Staff Report
City of Richmond, Virginia
Planning Commission

UDC 2022-24	Final Review	Meeting Date: 12/5/2022
Applicant/Petitioner	Bill Boston – Department of Public Utilities, Stormwater	
Project Description	FINAL location, character, and extent review of the Greening Greater Fulton project	
Project Location		
Address: ROW for 4900 and 5000 blocks of Government Road		
Property Owner: City of Richmond/ Adjacent Commercial Properties		
High-Level Details:		
Innovate Fulton, the Alliance for the Chesapeake Bay, and Groundwork RVA have partnered together to create a concept plan for stormwater retention infrastructure and environmentally sustainable streetscape improvements along Government Road between Williamsburg Road and Carlisle Avenue. The project will include permeable pavement, street trees, rain gardens, a small pedestrian plaza, and a public art installation. The project will enhance the pedestrian experience; further many citywide sustainability and environmental goals; increase business attraction; and provide important investment in transportation and green infrastructure in an area that is historically underinvested and low income.

TREE LAWN AT JUNCTION

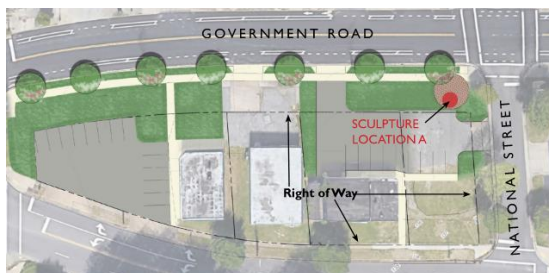
A continuous tree lawn is proposed between the sidewalk and street curb, rather than smaller and more confined tree wells, which will facilitate greater tree health.
